REMARKS

Fig. 4a

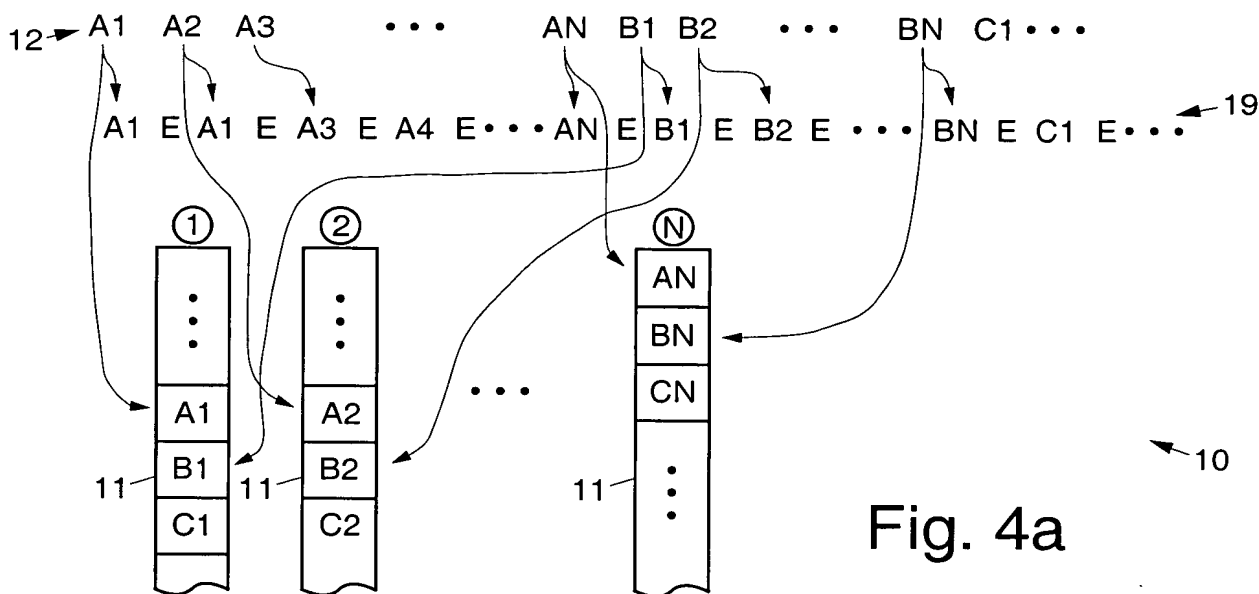
As to the Examiner's issue regarding pages 17 and 18 and Fig. 4a that "numerous references to Fig 4a showing a "device 10" appear to be inaccurate", reference numeral 10 at the right side of the figure identifies the device. Reference number 11 in Fig. 4a identifies data registers 11, which are clearly part of a device. Reference number 12 in Fig. 4a identifies a data stream 12 which is processed by the device 10 using the data registers 11. Reference number 19 in Fig. 4a identifies an output transmission stream 19 which is output from the device 10. All of the elements shown in Fig. 4a relate to a device. It is therefore respectfully submitted that Fig. 4a illustrates a device 10, and the specification is correct.

Fig. 6

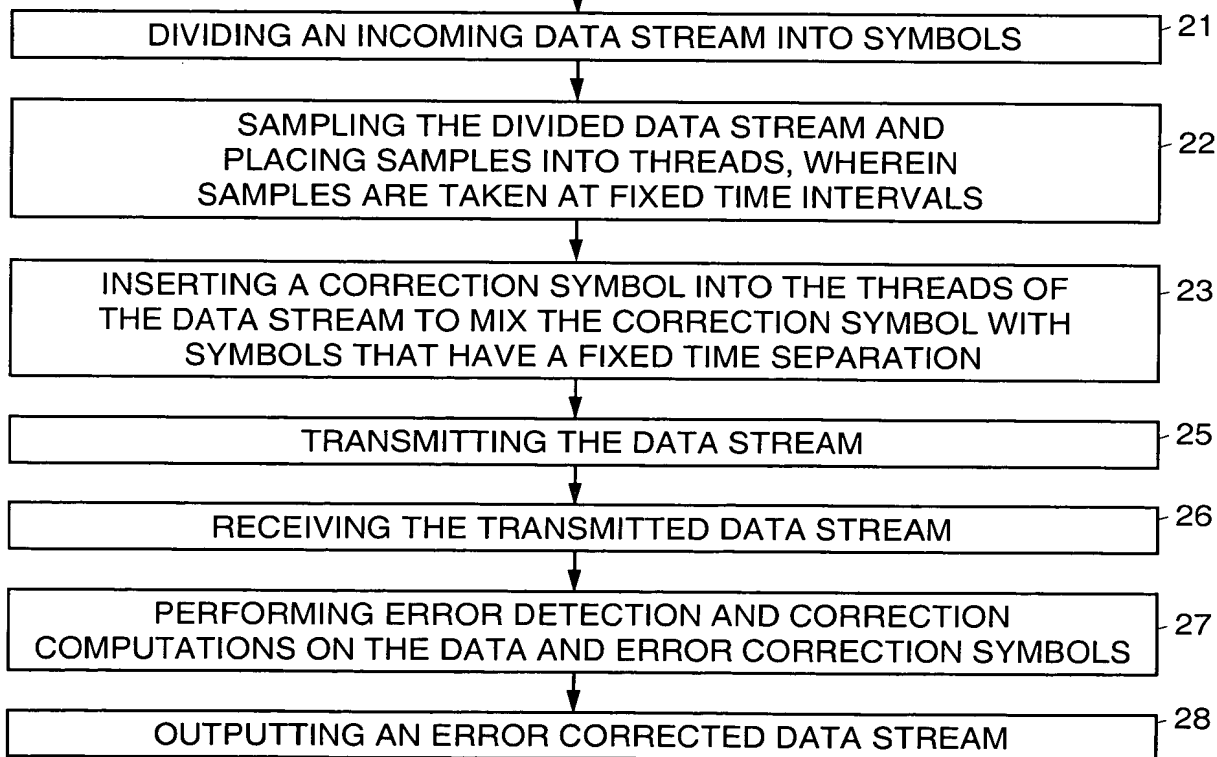
The drawings were objected to because reference numeral "10" should be "20" in Figs. 5 and 6. It is respectfully submitted that Figs. 5 and 6 have been amended to correct the numbering error. Enclosed is a marked up drawing showing proposed amendments marked in red ink. Also enclosed is a replacement reproducing master containing the amendments. Withdrawal of the Examiner's rejection of Claims 1-18 is respectfully requested.
